New bolt - tensioning pulley 531 0278 30

Model: Transporter T4

LuK AS Part No.: 531 0278 30

Fig. 3: LuK AS bolt

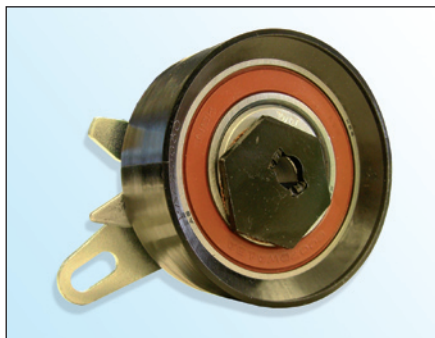
As part of the continuous development of our products and quality assurance, LuK AS now supplies a new bolt (**fig. 3**) with the tensioning pulley **531 0278 30**.

Features:

- flat bolt head with Torx
- Bolt head \varnothing 18.5 mm
- Bolt grade 10.9
- Thread locking medium on the bolt
- Increased self-locking

LuK AS recommends replacing the original bolt (**Fig. 2**) with the supplied bolt.

Tightening torque: 20 ± 1,5 Nm
